## **NOTICE OF THE REGULAR MEETING OF THE PLAN COMMISSION**

## **AGENDA FOR REGULAR MEETING VILLAGE OF TINLEY PARK PLAN COMMISSION**

# PLAN COMMISSION STAFF REPORT

# PLAN COMMISSION STAFF REPORT

1 SITE PLAN  
SCALE: 1" = 40'-0"

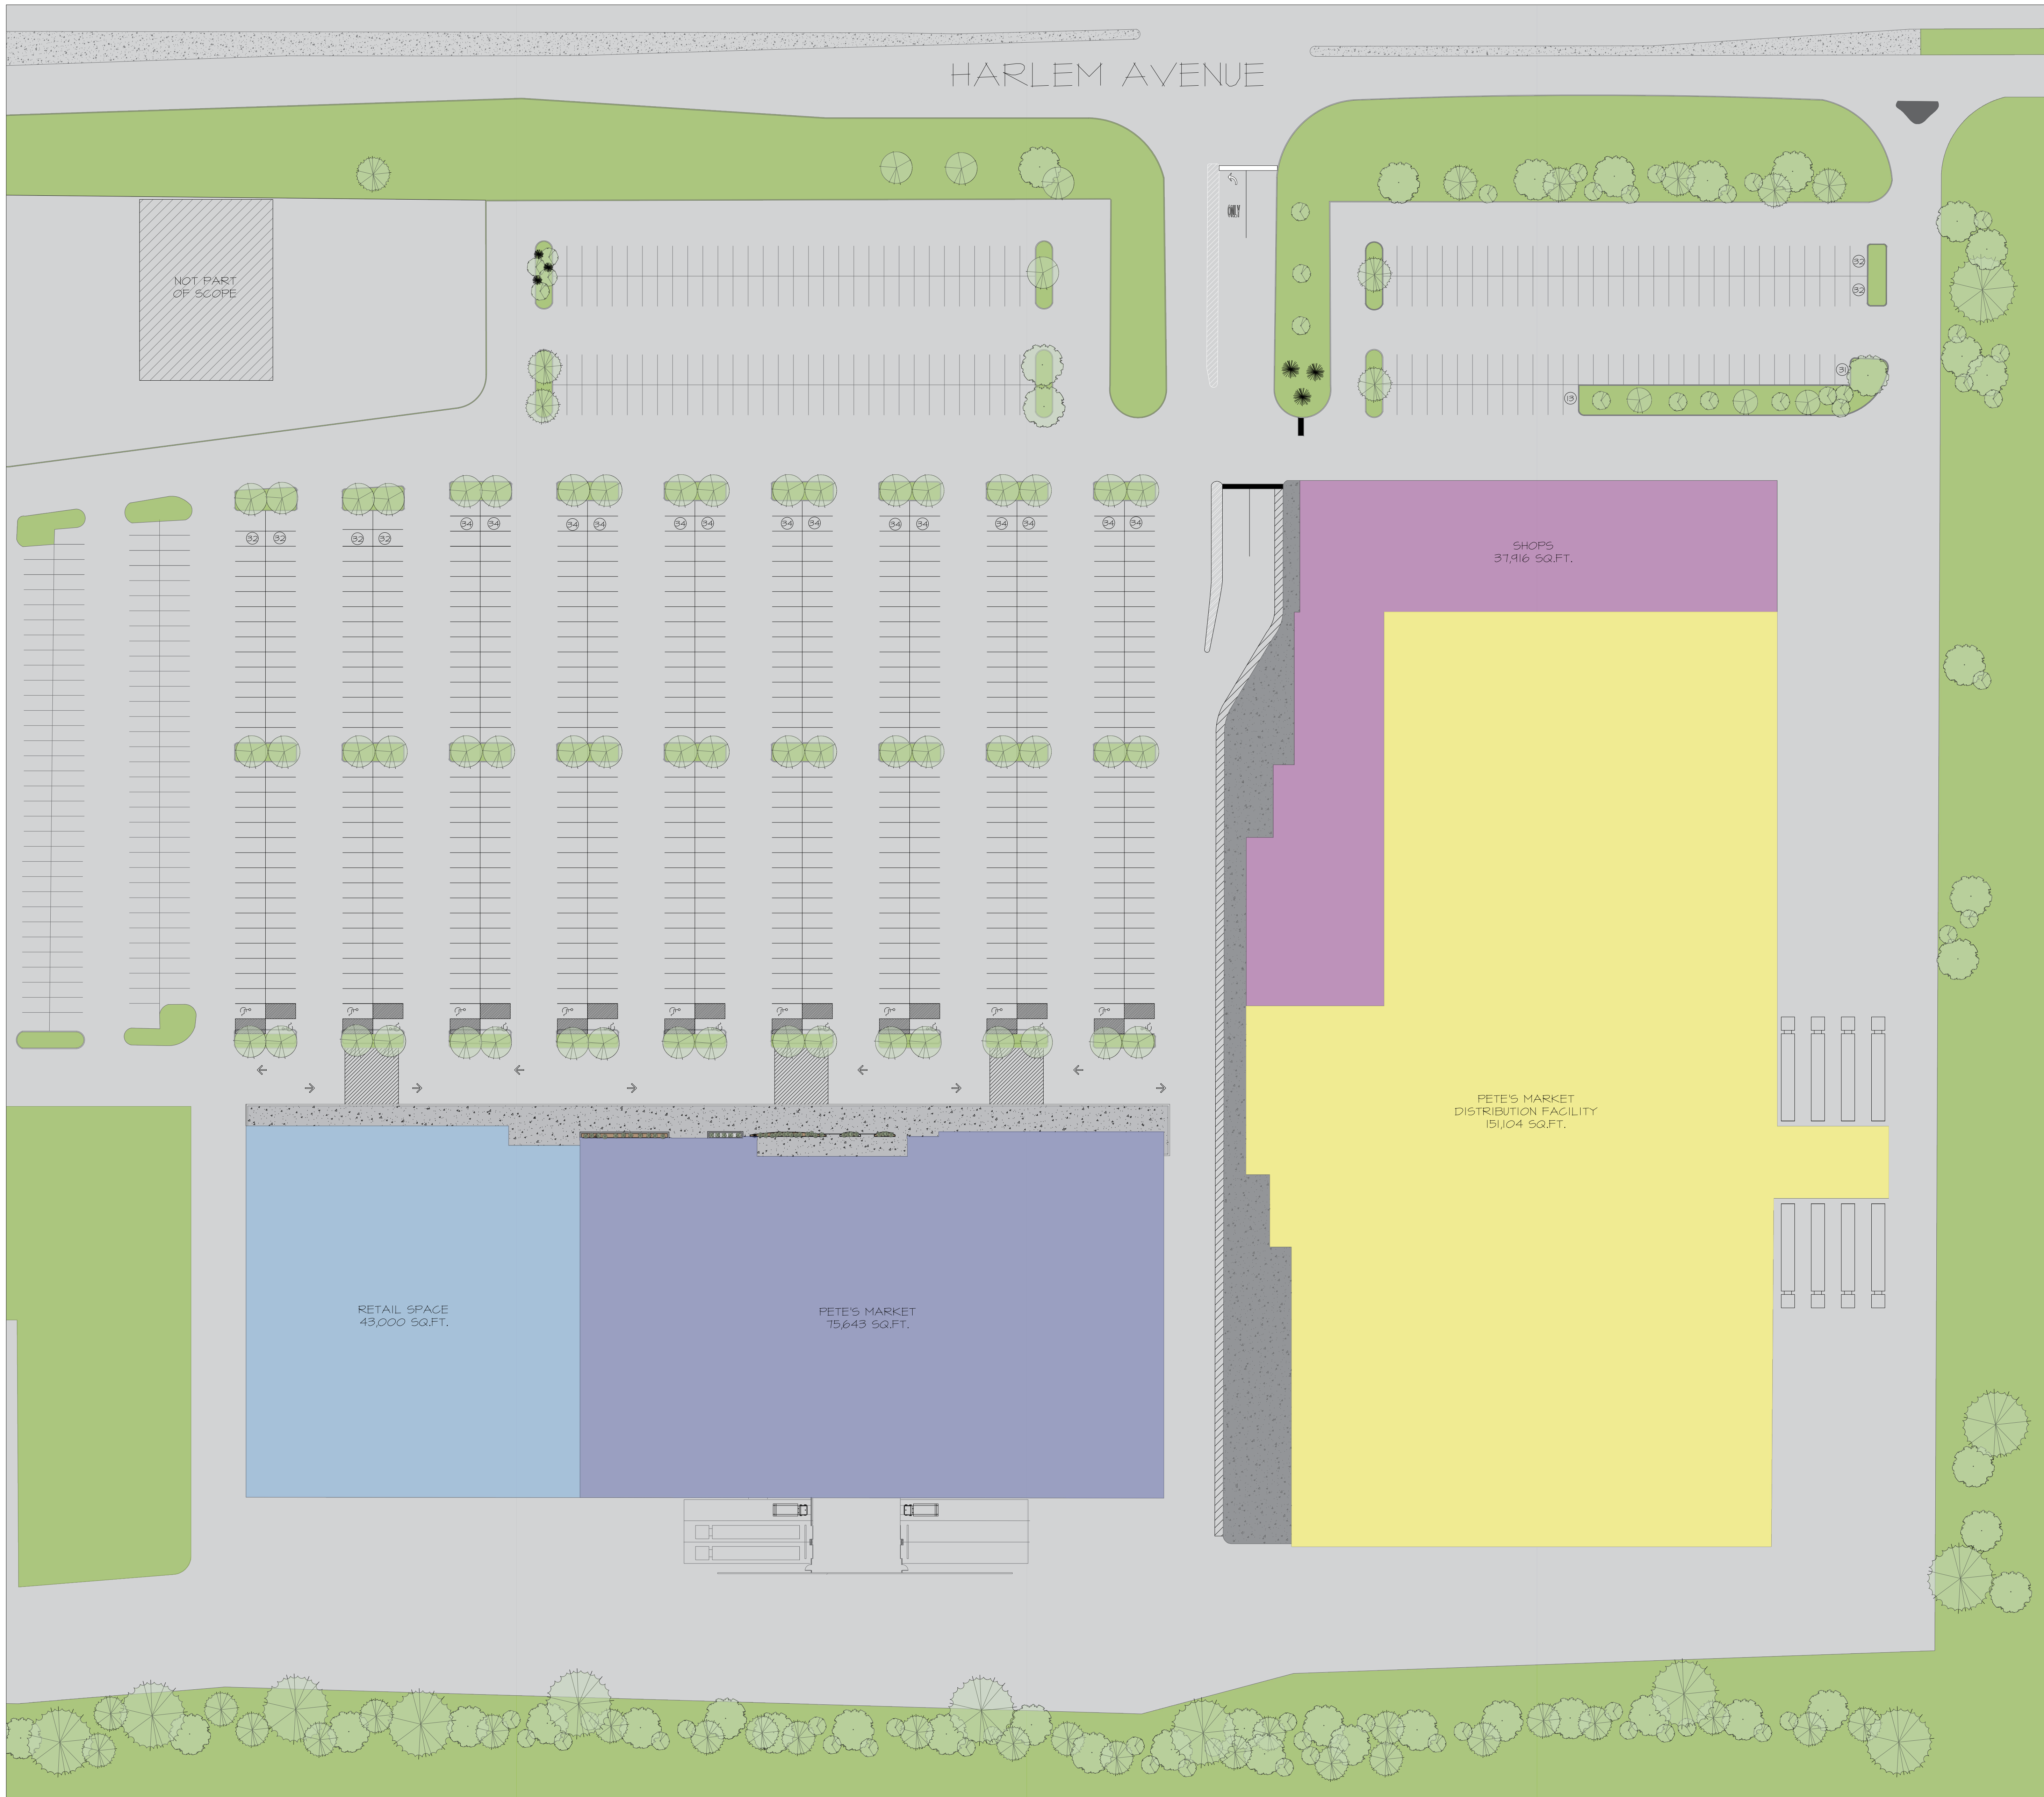
The plan provides for the redesign of the parking field so that the drive aisles are perpendicular to the main retail tenant (Pete's Fresh Market.) Staff supports the reconfiguration of the parking lot; however, the south aisle will need a landscape buffer to avoid conflicts from cars backing into the main drive aisle that runs along the north side of the K-Mart building. (See diagram below.)

**Open Item # 8: Discuss recommending for approval the Site Plan Concept with recommendations as noted by staff and conditioned upon the removal of the non-conforming ground sign and the installation of a sidewalk along Oak Park Avenue south of 163<sup>rd</sup> Street as part of Phase 2 improvements.**

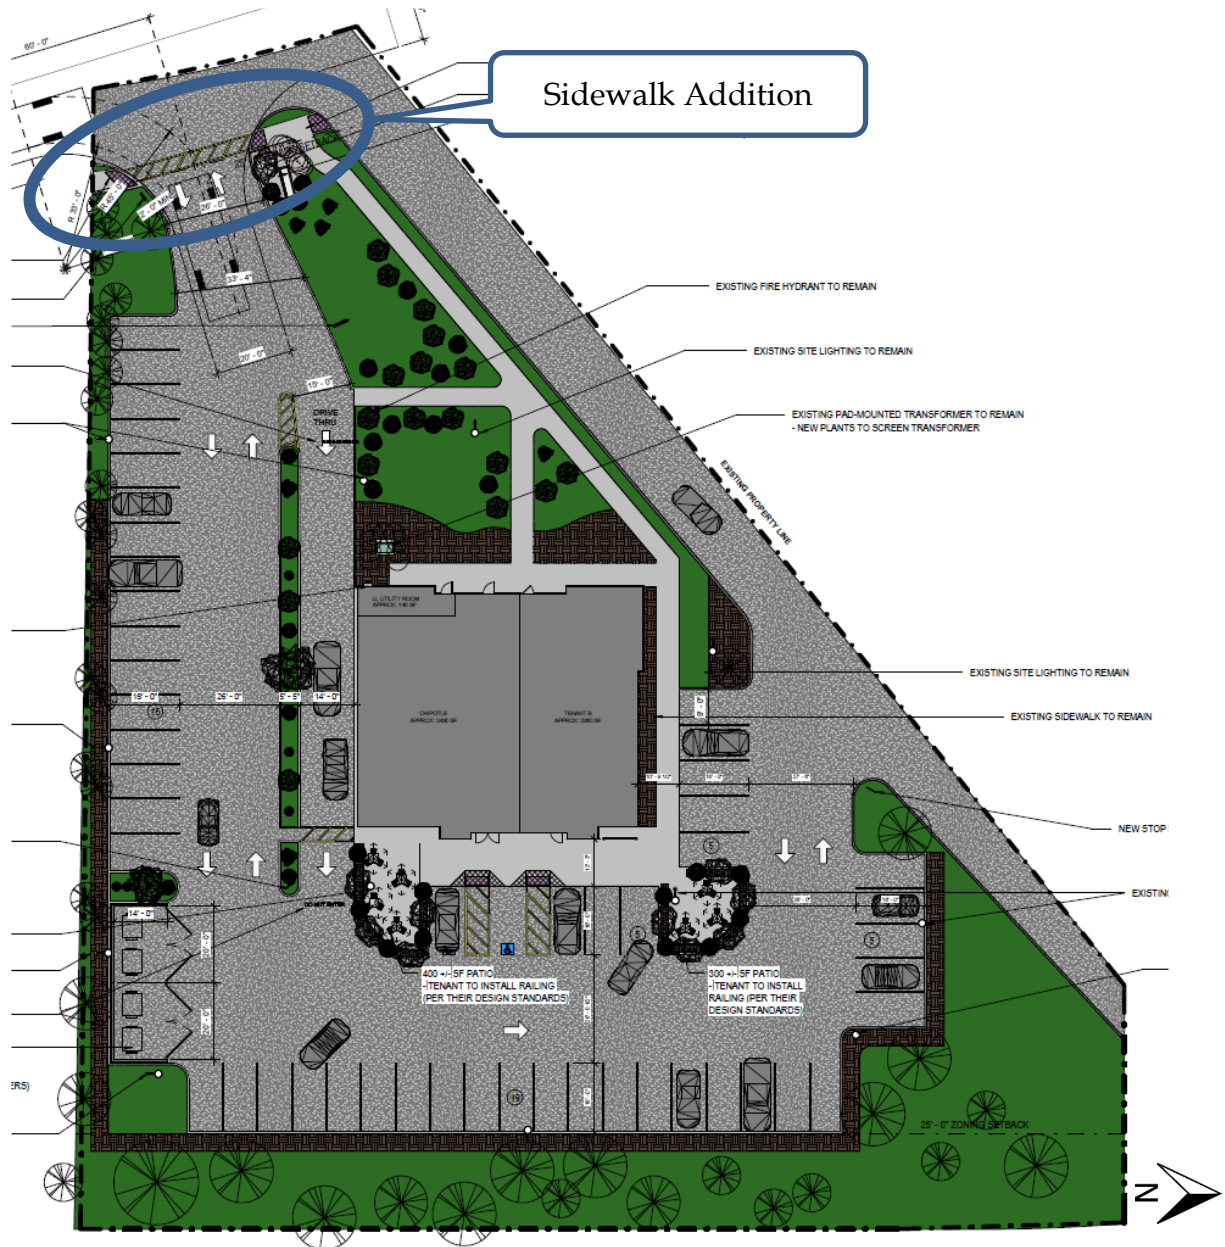
While the lane will not function as a typical drive-thru, there still may be some stacking space needed if multiple vehicles show up at one time. A total stacking of six vehicles with appropriate spacing is provided on the site. The stacking proposed is more than adequate based on their experiences at other similar locations. Total time for the pick-up is usually very short since the food is already made and paid for ahead of time before entering the lane. The total stacking might not be appropriate for many other concepts drive-thru demand, but was deemed appropriate for Jimmy John’s in 2019 based on their traffic and drive-thru analysis completed by Kimley-Horn. The “Chipotlane” concept will have even quicker wait times and lower demand than the Jimmy John proposal, so a new study was not recommended with this proposal. However, conditioning the approval of the special use for the drive-thru will help to ensure any future users of the drive-thru/pick-up lane have appropriate stacking and traffic studies to ensure there are no problems.

***Open Item #2: Include a condition of approval that any changes in drive up window protocol or future tenants requiring a drive-up window, will require a new traffic/drive-thru analysis to ensure the drive-thru stacking is sufficient prior to issuance of any permits or occupancy.***

### **Open Item #4: Discuss the proposed architecture of the building.**

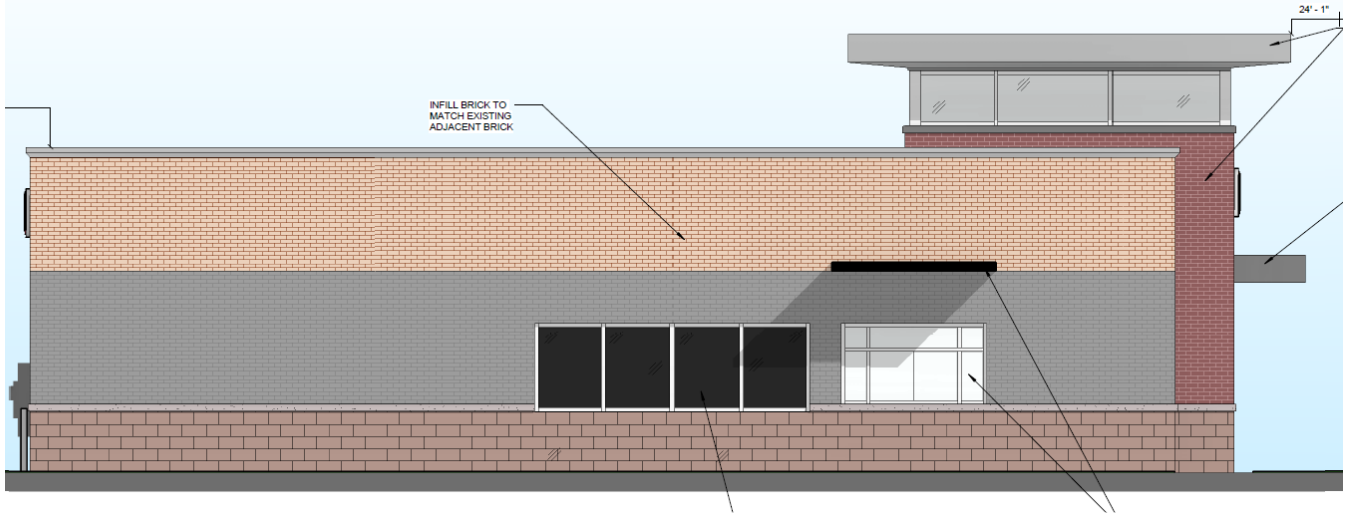
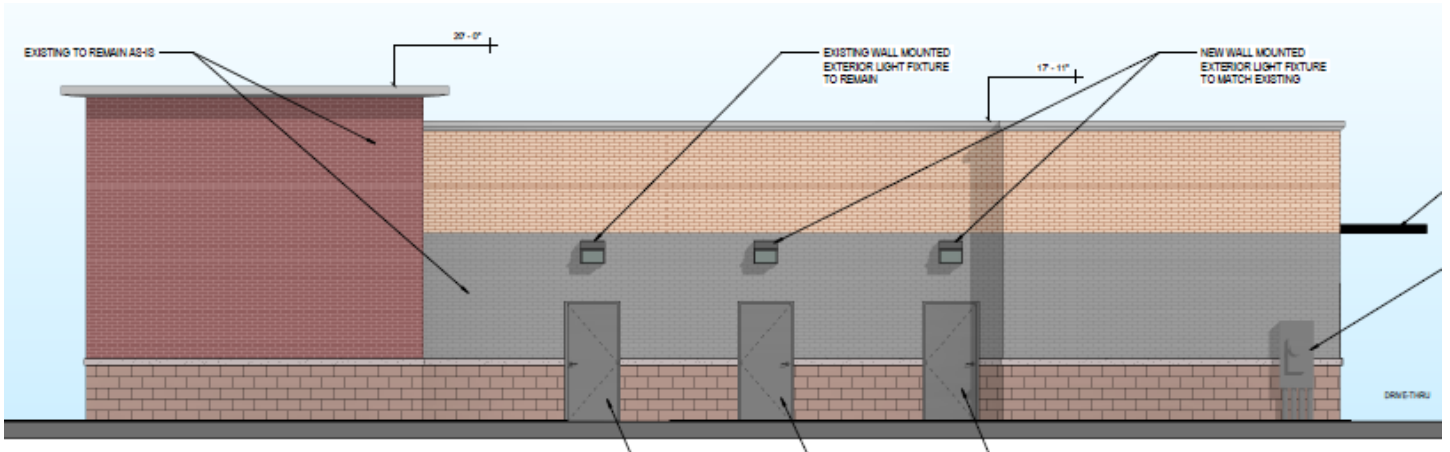
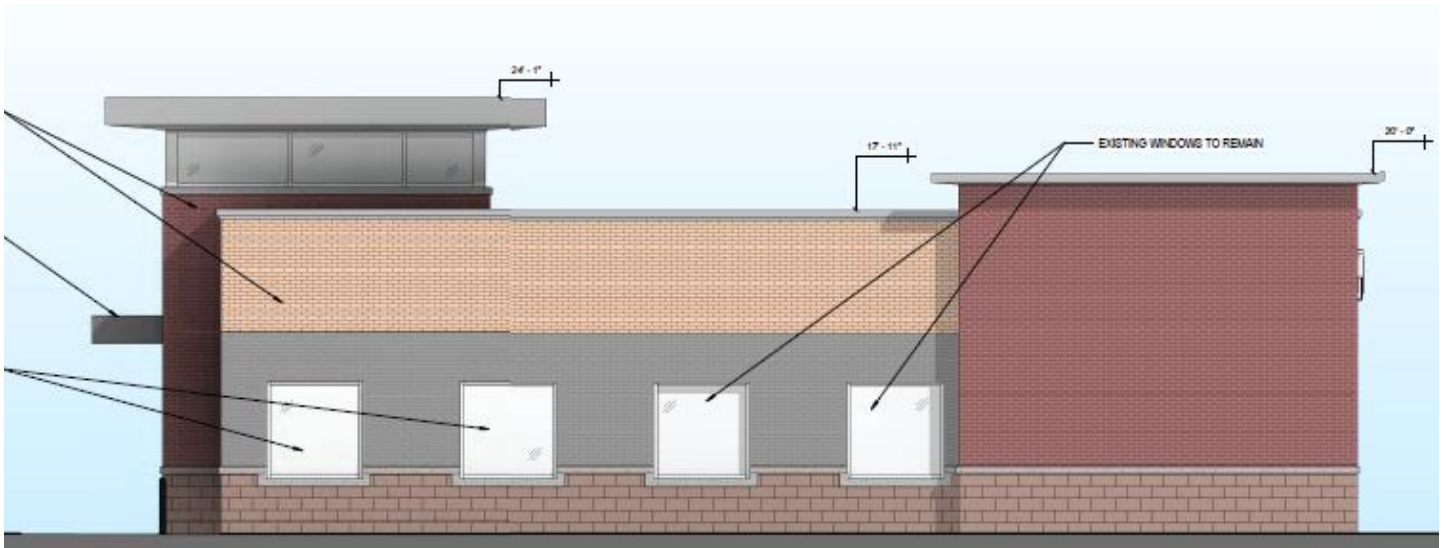
Staff recommended the Petitioner look into changes to the south and west elevations since they are becoming more visible with the change from a bank use to a multi-tenant commercial building. Staff initially recommended placing a canopy along the rear, adding a tower-element on the southwest corner matching the northwest corner, and adding additional windows. However, the Petitioner has noted that changes to the exterior have been minimized to keep the project technically and financially feasible. The current design avoids lengthy and costly construction and approval processes. Additionally, they note that the design of the building is attractive and that it was designed so that it was easily converted to a non-bank use such as their proposal.

Note that the coloring of the renderings below shows slightly different than what is proposed. The new awning/canopy will be black. The brick color on the building will remain as it exists now and the enclosure will match that color; there will not be grey brick as it appears horizontally in the middle of the building).

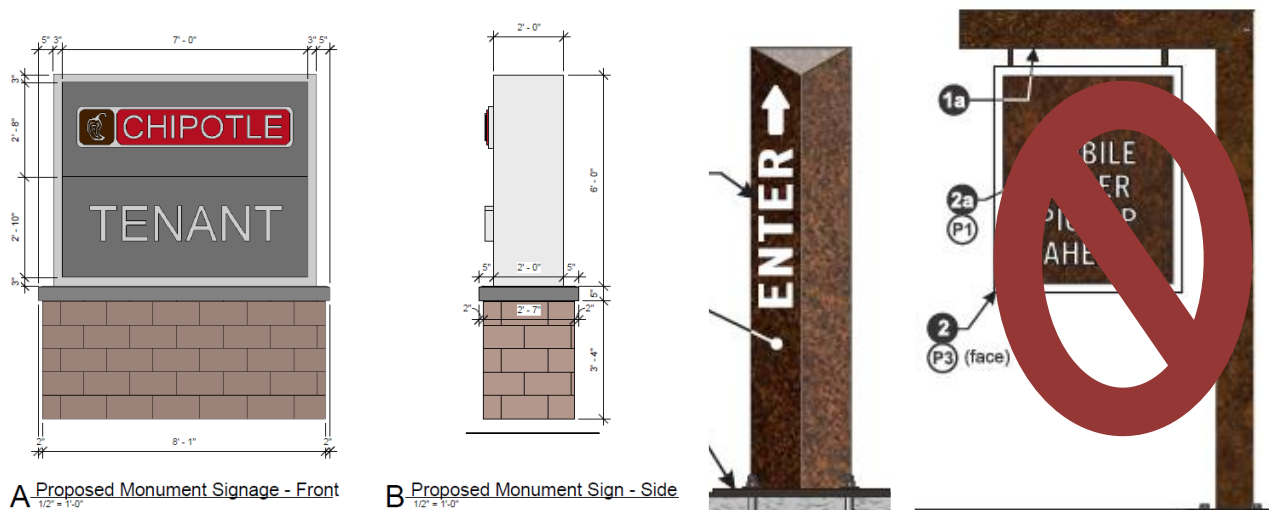
The proposed wall signage locations comply with the Brookside Marketplace PUD sign standards. However, the full dimensions of the wall signs are not indicated on the plans and will be the responsibility of the individual tenants. The proposed ground sign has been provided and complies with the standards as well.

Directional signage locations and designs have been provided and comply with the code requirements, with the exception of the “Mobile Order Pickup Ahead” hanging directional sign which is too tall and large for a directional sign. Staff has recommended that this be revised to meet the requirements of a maximum of four feet in height and six sq. ft. in size. These requirements have been met at all other drive-thru locations in Brookside Marketplace. Staff has suggested a sign similar in style to the “enter” sign with the wording reduced to “Order Pickup”.

**Open Item #5: Discuss “order pick up window’ sign and required revision.**
